## CITY OF GLENDALE, CA

### DESIGN REVIEW STAFF REPORT – SINGLE FAMILY

<b>June 29, 2023</b> <i>Decision Date</i>	<b>1550 Royal Boulevard</b> <i>Address</i>
<b>Administrative Design Review (ADR)</b> <i>Review Type</i>	<b>5650-019-004</b> <i>APN</i>
<b>PADR-000689-2022</b> <i>Case Number</i>	<b>Arthur Israelian</b> <i>Applicant</i>
<b>Chloe Cuffel, Planning Associate</b> <i>Case Planner</i>	<b>Raffi Saroyan</b> <i>Owner</i>

The project proposes a 955 square-foot addition at the rear of an existing two-story, 2,544 square-foot single-family dwelling (built in 1950) with an attached 400 square-foot garage located on a 16,888 square-foot lot. The proposed addition includes expansion of the existing lower level (partial underground basement) by 518 square-feet and adding 440 square-feet to the existing upper level. The total floor area of the house with the addition combined will be 3,499 square-feet.

**WINDOW SCHEDULE**

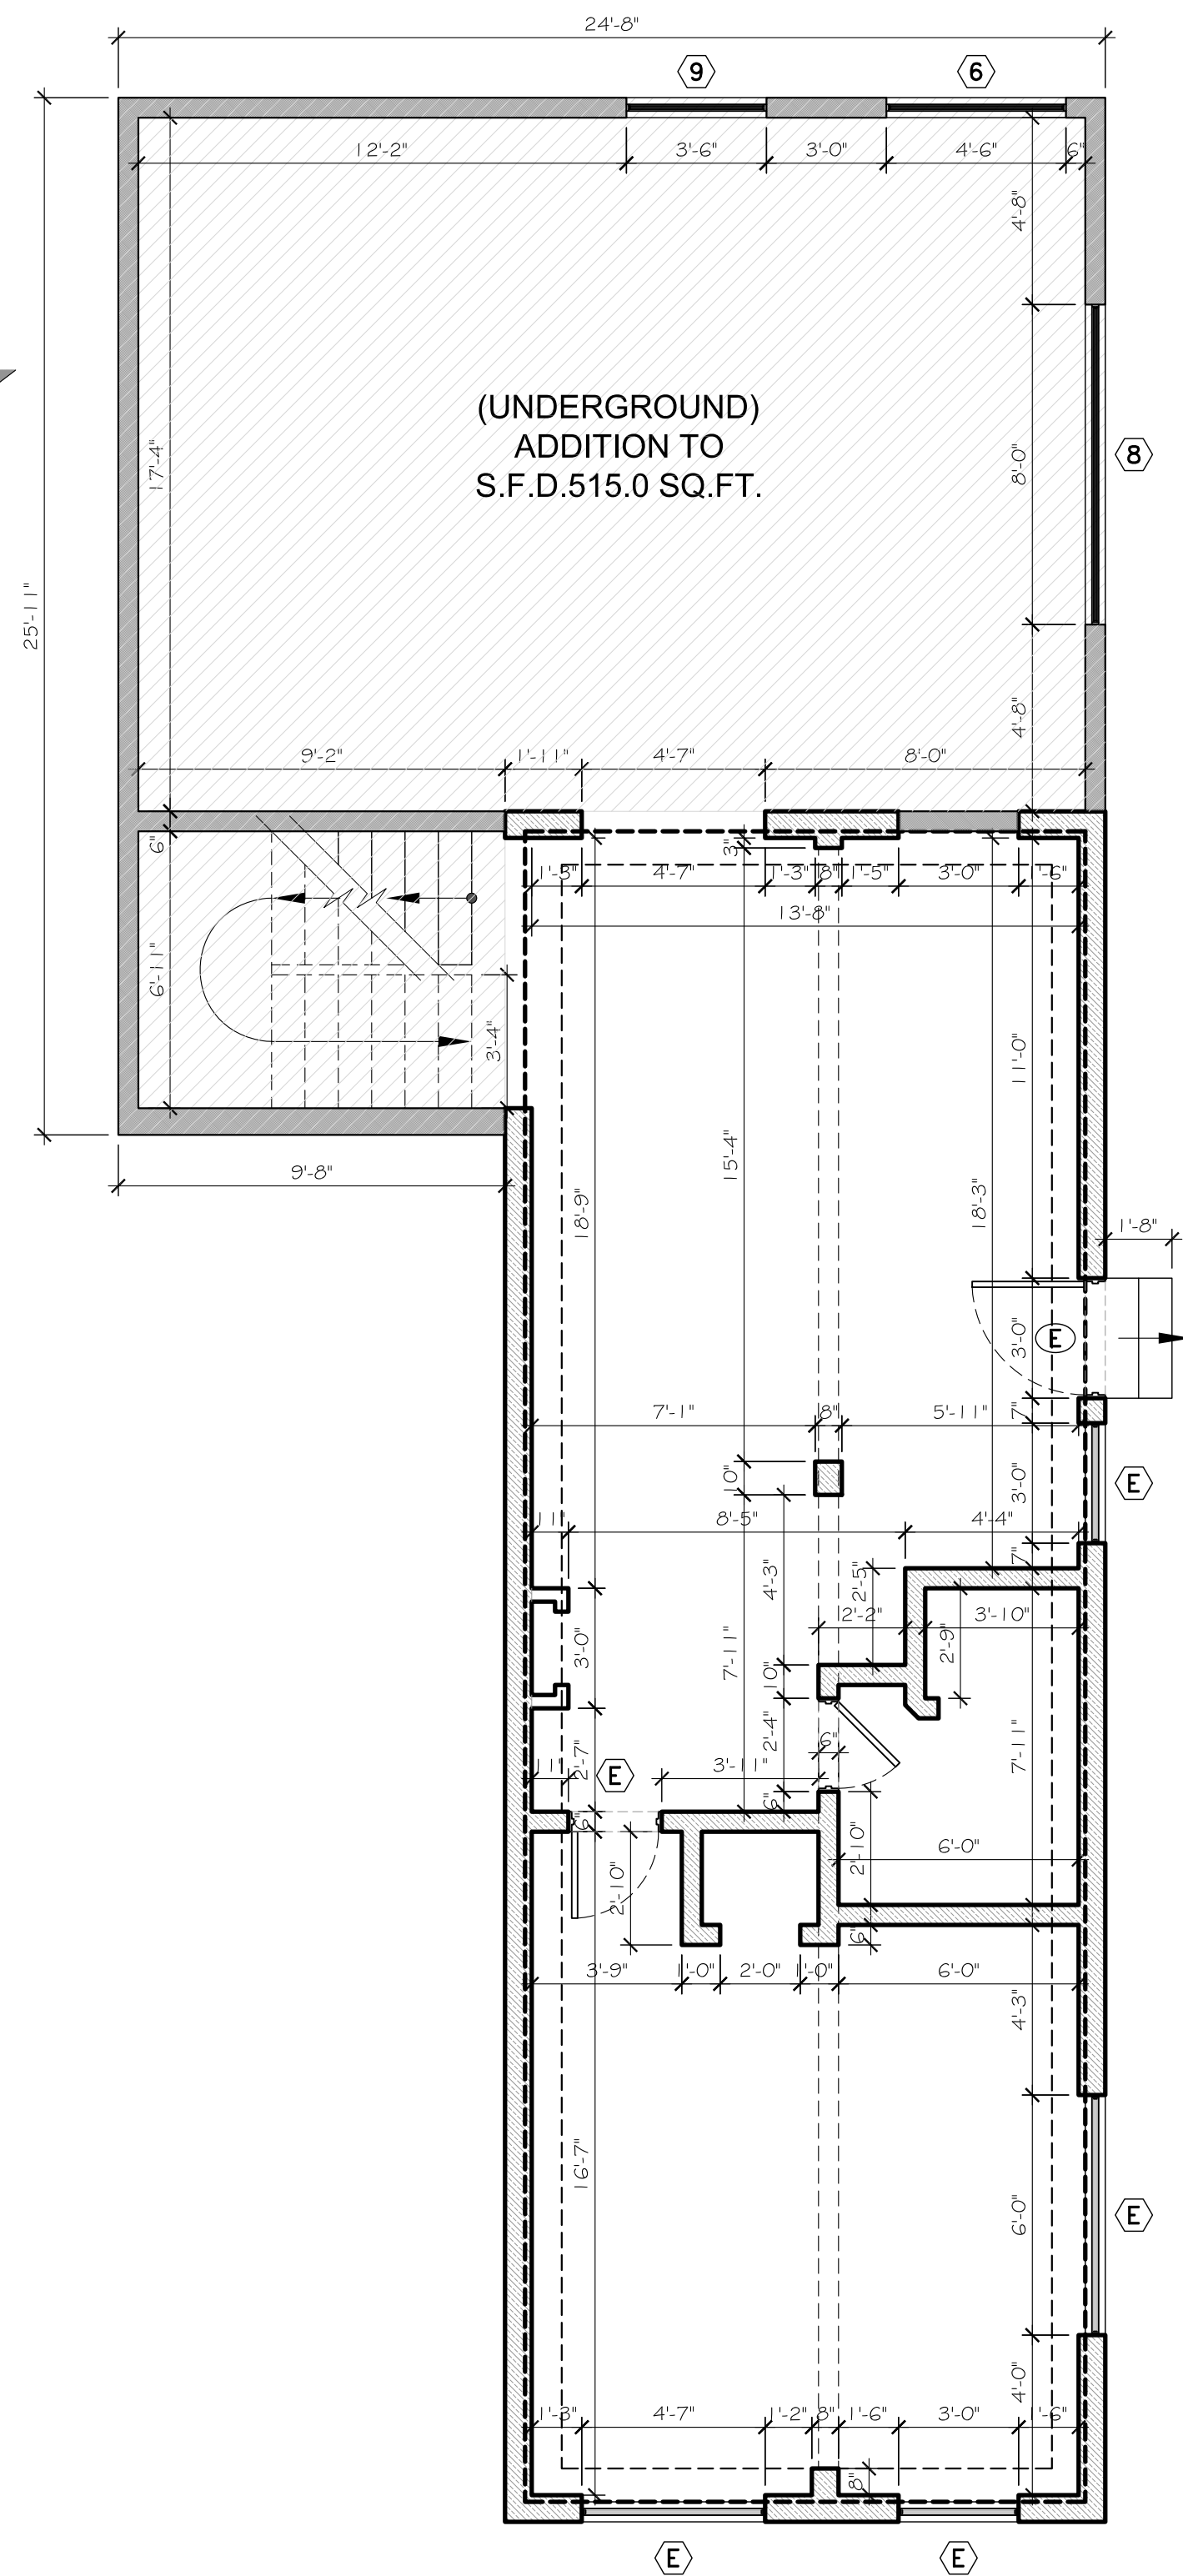
The window schedule shows aluminum for the proposed window materials, however the material board indicates vinyl. A condition is included to revise the material board to show aluminum windows consistent with the window schedule.

1. That the material board be corrected to reflect aluminum windows as the material for the addition windows.
  2. That the location of trash storage, mechanical (A/C) equipment, and downspouts be clearly identified on the plans for staff review and approval.
-
